March 3, 2022

Re: *Hearing Regarding Application for Variance*
Applicants: Edward and Peri Jacoubs (the 'Applicants')

I am writing to you in behalf of my client, Ms. Barbara Princiotta ("Ms. Princiotta"), regarding the hearing that is presently scheduled to take place on March 9, 2022. Based upon the information and materials that I have been able to review to this point, below please find a summary of some of the issues and concerns that should be addressed by the Board of Health (the "Board"), regarding this matter, and which serve as grounds for denial of the subject application (the "Application"), regarding 60 Arlington Drive (the "Property").

EXHIBIT A

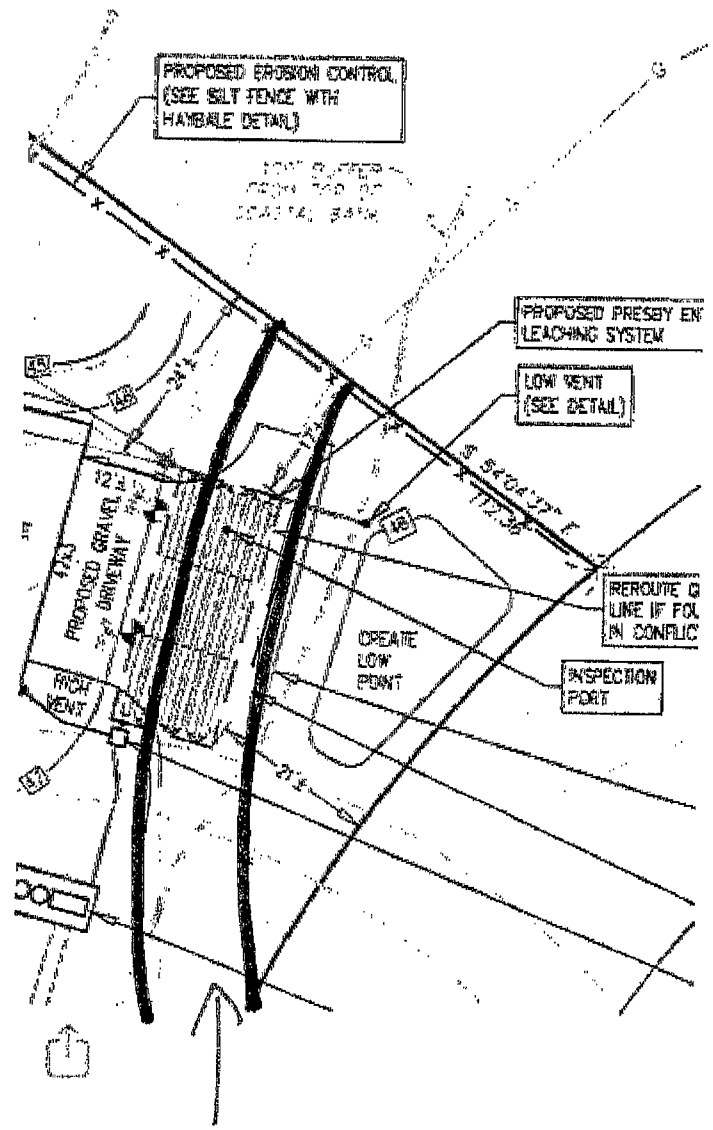
310 CMR 15.220(4)(b) provides, in relevant part, that: "Every plan for a system shall . . . include depiction of . . . the holder and location of any easements appurtenant to or which could impact the system." (Emphasis added.) The plan submitted with the Application, which is dated December 23, 2019, with revisions through October 19, 2021 (the "Plan"), does not depict any easement(s) burdening the subject property. Nevertheless, Ms. Princiotta's property, and other properties within the subject development, benefit from a deeded easement that passes through the front of the Property in the approximate area shown as "Gravel Drive" on

the Plan (the "Easement"). (For the convenience of the Board, a sketch plan showing the approximate location of the Easement is attached hereto as "Exhibit A".) Indeed, the Easement burdens the very area of the Property under which the Applicants are proposing to install the "Proposed Presby Enviro-Septic Leaching System". The Applicant's failure to depict the location of the Easement, and to identify the persons that benefit from the right to pass and repass over that Easement, is a material defect of the Plan.

PLAN OF
THE BOURNE ESTATE
 IN
BOURNE, BUZZARDS BAY.

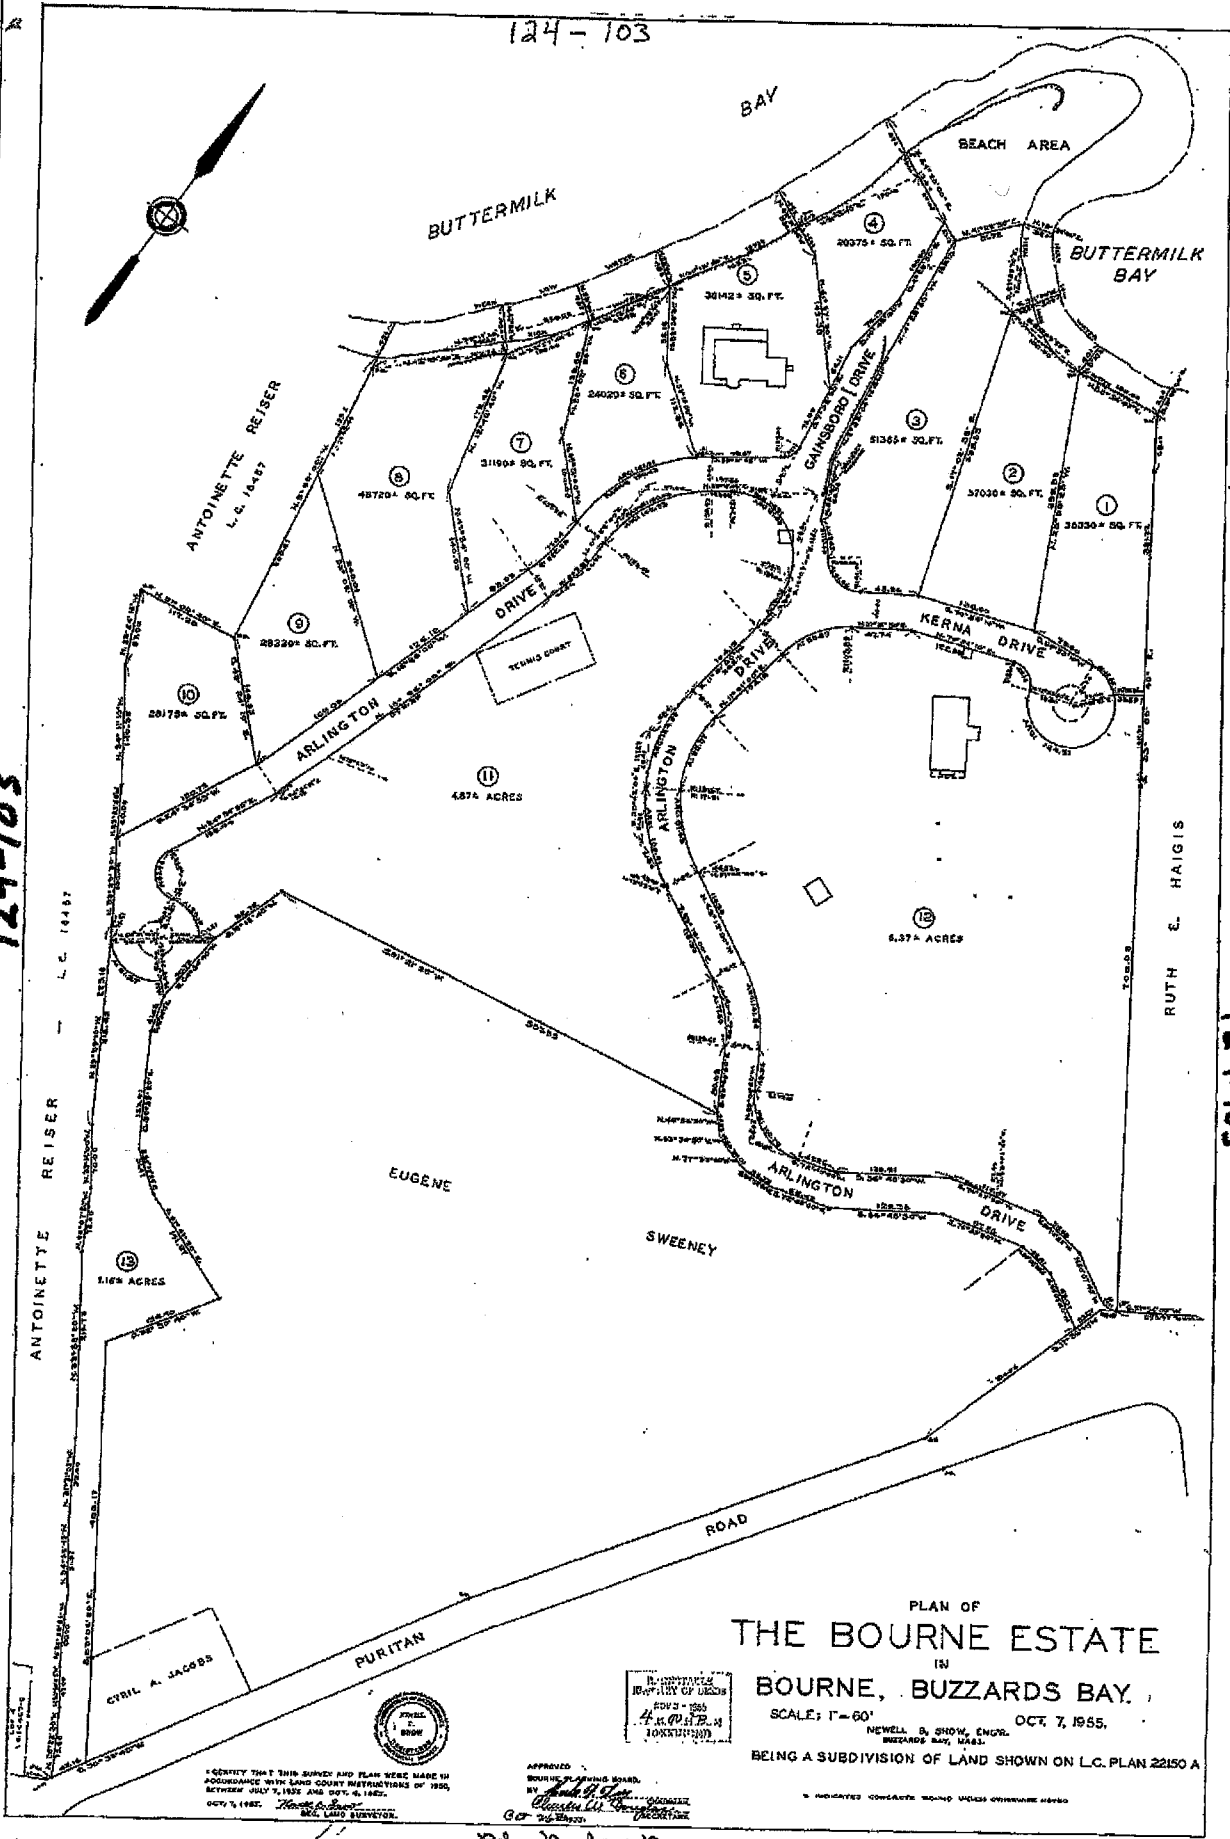
310 CMR 15.220(4)(a) provides, in relevant part, that: "Every plan for a system shall . . . include depiction of . . . the legal boundaries of the facility to be served." Ms. Princiotta notes that the subdivision plan that created the subject Property, which is dated October 7, 1955, and was recorded in the Barnstable County Registry of Deeds (the "Registry"), at Plan Book 124, Page 103 (the "Subdivision Plan"), includes several material differences from the Plan. (For the convenience of the Board, a copy of the Subdivision Plan, reduced in size, is attached hereto as "Exhibit B".) These differences include, *inter alia*, (a) the square footage for the subject property shown on the Subdivision Plan is 24,020, and the Plan suggests that the subject property consists of 24,054 square feet; and (b) the linear courses and the lot lines shown on the Plan do not accurately follow the courses and distances shown on the Subdivision Plan. The "legal boundaries" of the subject property are established by the Subdivision Plan.¹ Accordingly, the Applicants' failure to abide the boundaries established on the Subdivision Plan constitutes a violation of the unambiguous language of 310 CMR 15.220(4)(a).

¹ It is curious that although 310 CMR 15.220(4)(a) requires the Applicant to show the "legal boundaries" of the subject Property, the Plan shows only the approximate orientation of the Property's boundary lines. However, the Subdivision Plan includes definitive statements of the precise orientation of the boundary lines, which the Applicant failed to follow. In addition, each of the distances to boundary lines and each variance shown on the Plan is expressed as "±". This lack of precision represents another defect in the Plan, and another basis for the Board's rejection of the Application for failure to comply with 310 CMR 15.220(4)(a).
